PLANNING DEPARTMENT – Development Review Services

July 10, 2014

**Re: Garcias Kitchen Food Prep & Catering
Grading and Drainage Plan
Engineer's Stamp Date: not stamped (J13/D096)**

GRADING AND DRAINAGE PLAN

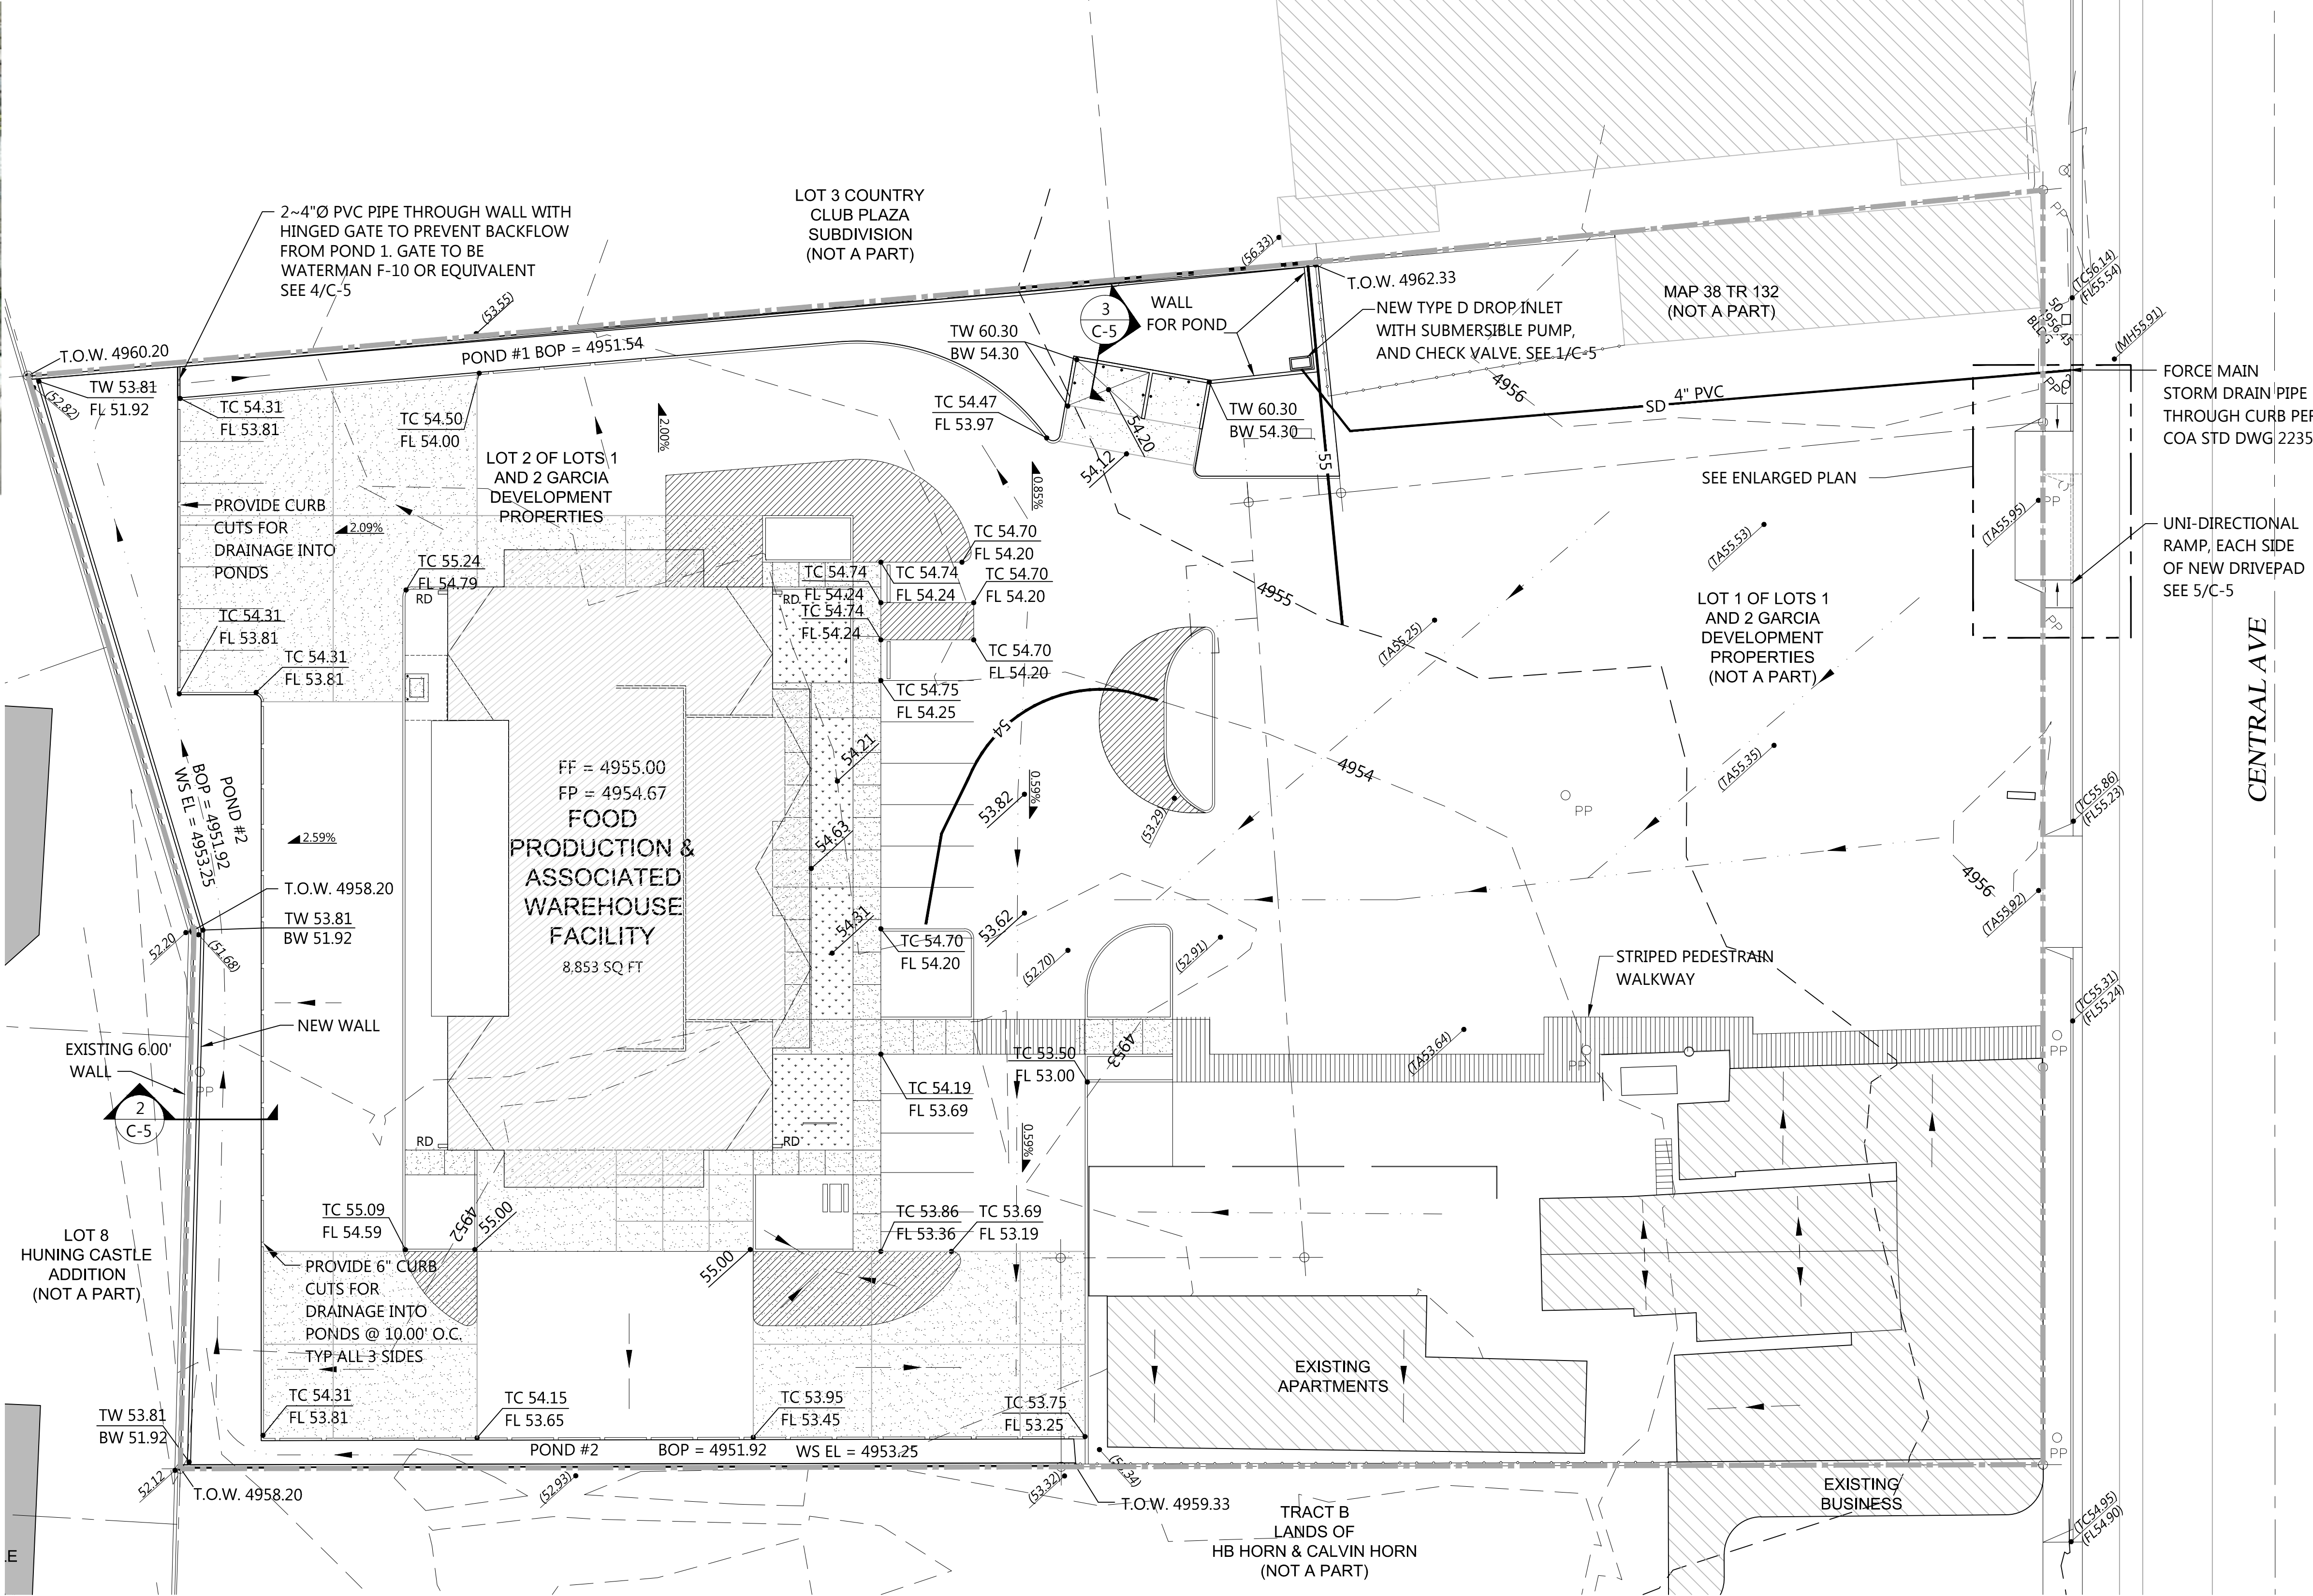
1. All plans and calculations need to be stamped by an engineer.
2. Onsite flows from the existing restaurant and apartments must be accounted for. The proposed curb south of these existing structures does not allow roof runoff from these structures to drain to Pond 2.

3. Roof runoff from the apartments appear to drain offsite to east and then reenter the property and drain to south west, along with some amount of offsite flows. LIDAR contours support this and so this onsite/offsite flows need to be accounted for. In addition, it appears that a wall is to be built along west property boundary. How will flows from apartments reenter?

4. Sections thru pond on East and West property boundaries need to be shown to indicate how flows will reenter, or how overflows will be contained on site.

5. It appears that Pond #2 Volume should be the total volume of both ponds #2 and #3 from the previous submittal. With a combined larger volume, the WSEL will be lower.

6. While a check valve is indicated on the plans, it is not clear where the check valve will be located. Indicate location of check valve. Also indicate what construction will be done thru Work Order and the CPN #.

1
C-5

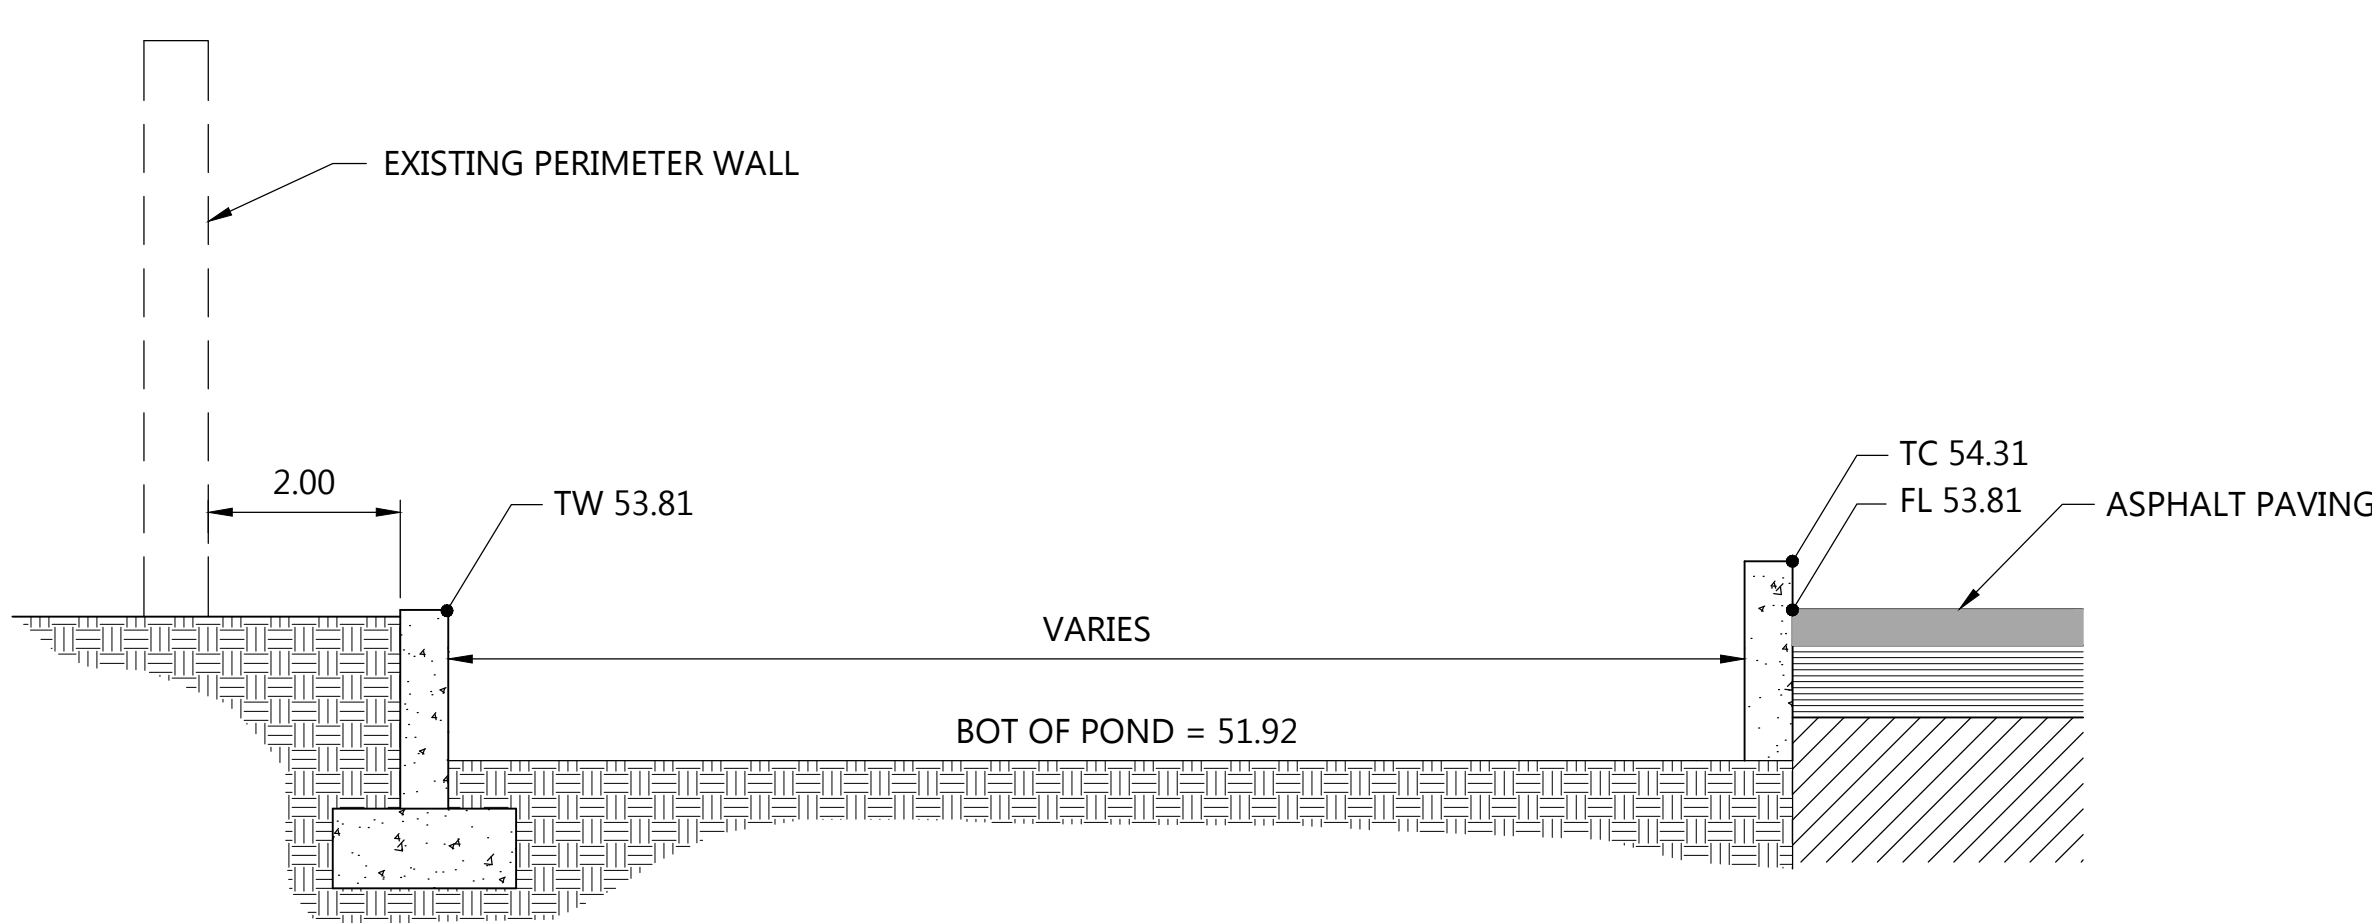
7. Details 1/C-5 and 3/C-5 show retaining walls that need to be designed, detailed, and dimensioned.
8. Pump cut sheets provided show general information but do not show where on the curve the pump will operate (which is typically shown on a system curve), nor are there supporting calculations. Please provide.
